Re: Turkey Point Units 3 and 4

Revised Response To Request For Additional Information Question Six Regarding Supplemental Response to NRC Request for Information Pursuant to 10 CFR 50.54(f) Regarding the Flooding Aspects of Recommendation 2.1 of the Near-Term Task Force Review of Insights from the Fukushima Dai-ichi Accident

NRC RAI No. 6:**Section 3.2 Local Intense Precipitation and Associated Site Drainage**

Figure 6-1 – Points of Interest Overlaid with Site Drawing

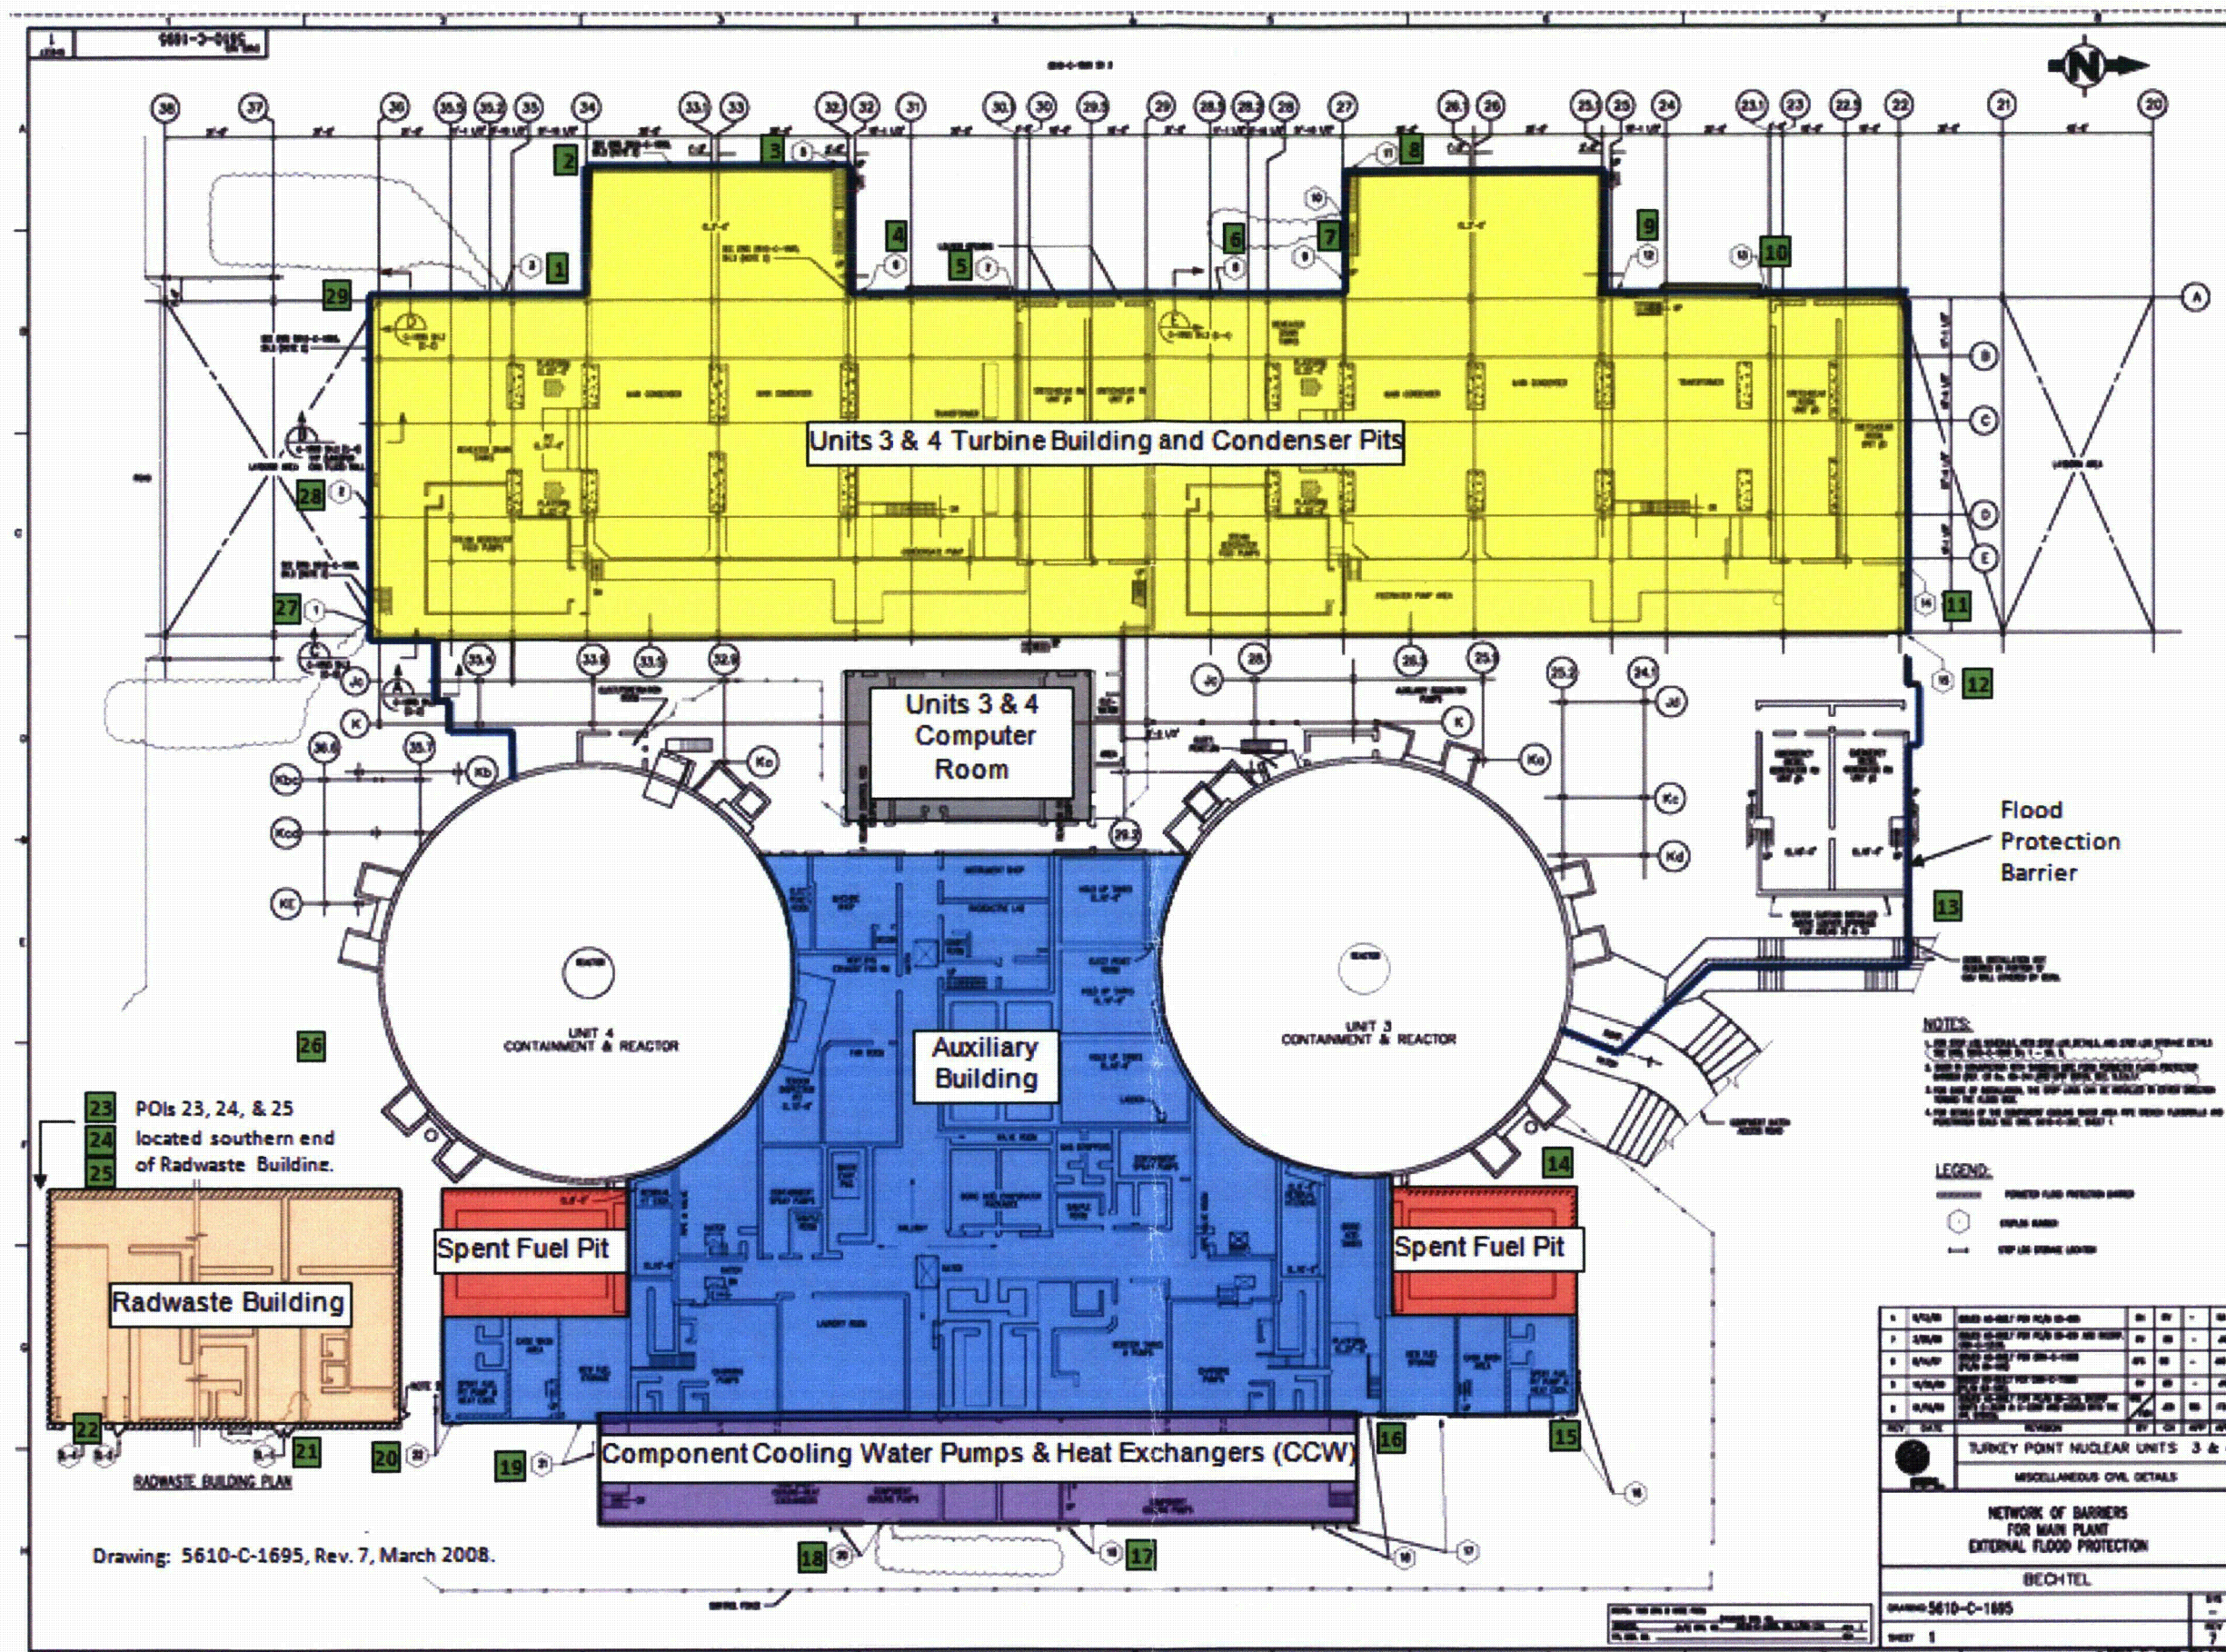
The NRC staff requests additional information to complete its review of the tabulated maximum predicted water elevations, depths, and flow velocities at 33 discrete points of interest, which the licensee identifies as potentially vulnerable areas. The NRC staff requests the licensee to provide a diagram or site plan that identifies/labels the facilities or buildings associated with the 33 locations for which flow depths and elevations are calculated for local intense precipitation Scenario A (see Table 4-2 of the FHRR). The NRC staff also requests the licensee to provide the maximum elevations and heights above local grade at the exterior of safety-related structures associated with these 33 locations. Please also confirm that evaluation of the resulting effects of water that has entered these structures will be evaluated and submitted as part of the integrated assessment.

The 33 discrete points of interest (POI) that were selected are related to potentially vulnerable areas such as openings in the perimeter flood barriers where water could build up and backflow into buildings. As requested, Figures 6.1 and 6.2 identify the facilities or buildings associated with the 33 POI locations. Figure 6.1 shows facilities or buildings associated with POIs 1 through 29 and Figure 6.2 shows facilities or buildings associated with POIs 30 through 33.
